CITY PLAN COMMISSION**THURSDAY, APRIL 10, 2025****FILE NUMBER:** S245-130**SENIOR PLANNER:** Hema Sharma**LOCATION:** Northwest Highway/State Highway Loop No. 12 at Midway Road, north of Cochran Chapel Road**DATE FILED:** March 13, 2025**ZONING:** R-10(A), R-1ac(A)**CITY COUNCIL DISTRICT:** 13**SIZE OF REQUEST:** 7.109-acres**APPLICANT/OWNER:** Cochran Chapel United Methodist Church**REQUEST:** An application to create one 7.109-acre lot from a tract of land in City Block 5075 and 5076 on property located on Northwest Highway/State Highway Loop No. 12 at Midway Road, north of Cochran Chapel Road.**SUBDIVISION HISTORY:** There has been no recent platting activity within close proximity to this request.**STAFF RECOMMENDATION:** Section 51A-8.503 states that "lots must conform in width, depth and area to the pattern already established in the adjacent areas, having due regard to the character of the area, its particular suitability for development, and taking into consideration the natural topography of the ground, drainage, wastewater facilities, and the proposed layout of the streets.

PRELIMINARY PLAT

COCHRAN CHAPEL ADDITION
LOT 1, BLOCK A/5075
OUT OF THE
JAMES L. FAROUH SURVEY, A

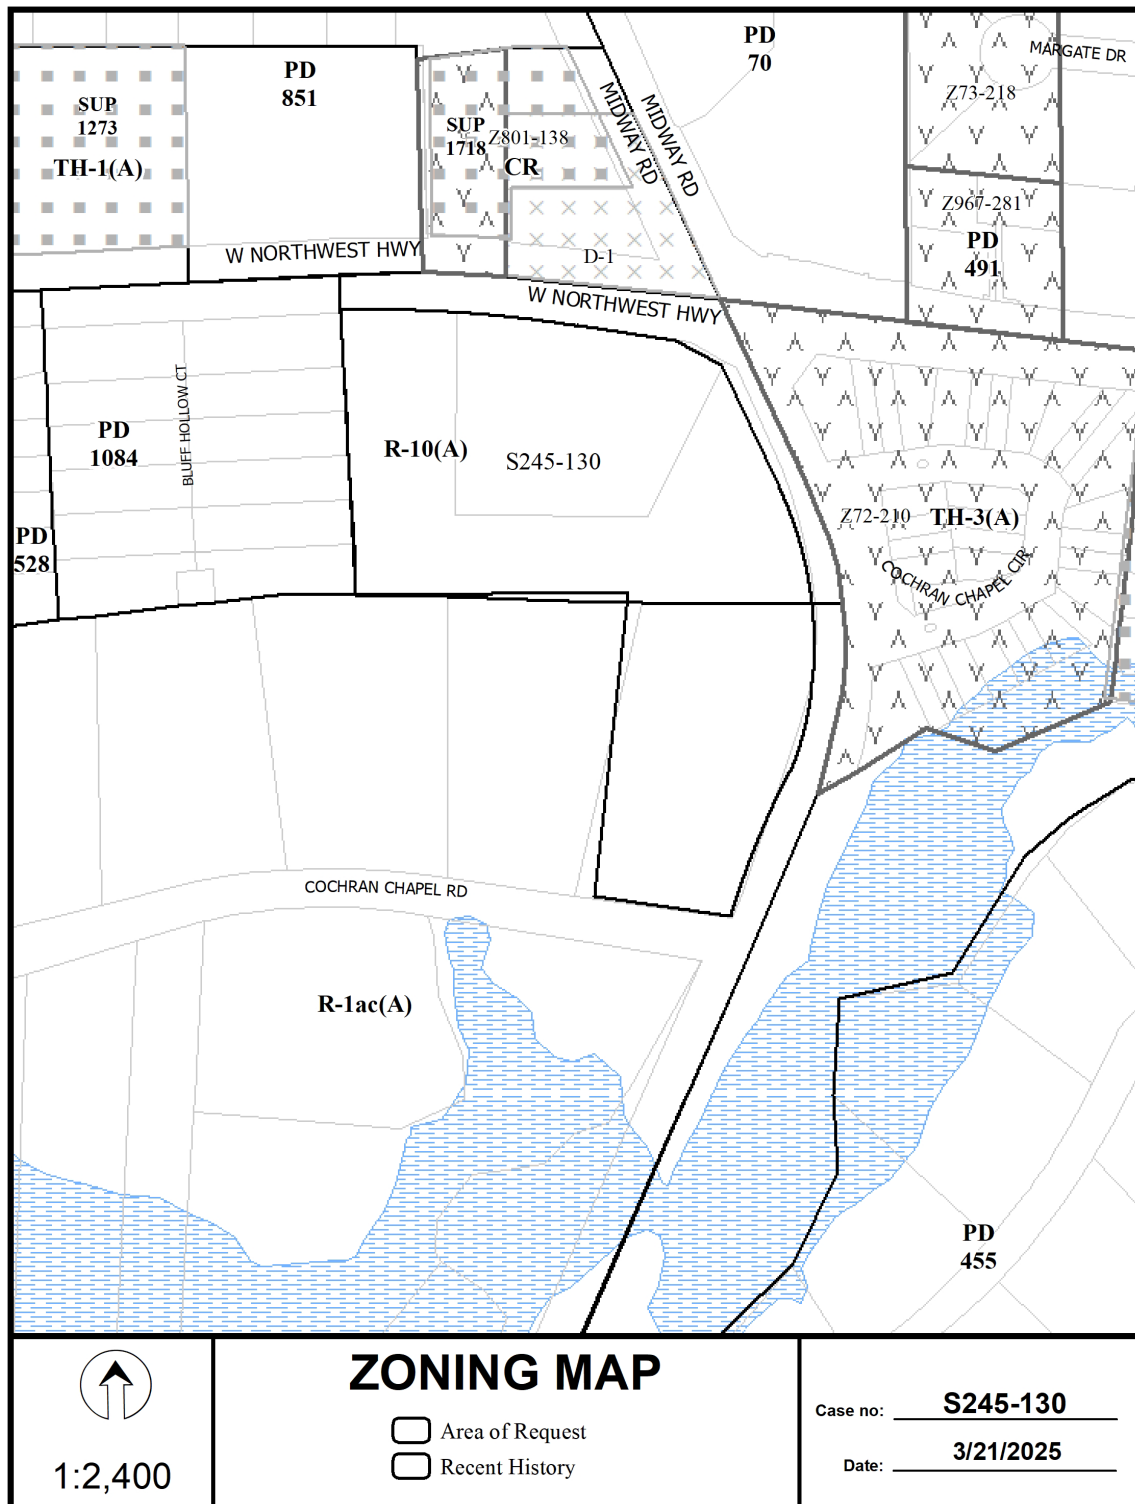
16. On the final plat, dedicate 53.5 feet of right-of-way (via fee simple) from the established center line of Northwest Highway/State Highway Loop No. 12. *Section 51A 8.602(c)*
17. On the final plat, dedicate 40 feet of right-of-way (via fee simple) from the established center line of Midway Road. *Section 51A 8.602(c)*
18. On the final plat, dedicate 28 feet of right-of-way (via fee simple or street easement) from the established centerline of Cochran Chapel Road. *Sections 51A-8.602(c), 51A-8.604(c) and 51A-8.611(c)*.

19. On the final plat, dedicate a minimum 25-foot by 25-foot corner clip (via Fee Simple or Street Easement) at intersection of Northwest Highway/State Highway Loop No. 12. and Midway Rd per 51A 8.602(d)(1).

20. On the final plat, dedicate a minimum 5-foot by 5-foot corner clip (via fee simple or street easement) at the intersection of Cochran Chapel Road & Midway Road. Section 51A 8.602(d)(1)

24. Prior to final plat, submit a completed final plat checklist and all supporting documents.
25. On the final plat, chose a new or different plat name.
26. Prior to final plat, clarify abstract.
27. On the final plat, show water easement, Instrument Number 20070193195, O.P.R.D.C.T.
28. On the final plat, show storm drainage easement, Volume 69134, page 1752, D.R.D.C.T.

32. On the final plat, change "Northwest Highway" to "Northwest Highway/State Highway Loop No. 12". Section 51A-8.403(a)(1)(A)(xii).
33. On the final plat, change "Midway Road Formerly Midway Church Road" to "Midway Road (FKA Midway Chapel Road)". Section 51A-8.403(a)(1)(A)(xii).
34. On the final plat, change "Cochran Chapel Road" to "Cochran Chapel Road (FKA Lakemere Drive)". Section 51A-8.403(a)(1)(A)(xii).
35. On the final plat, identify the property as Lot 1 in City Block B/5075.
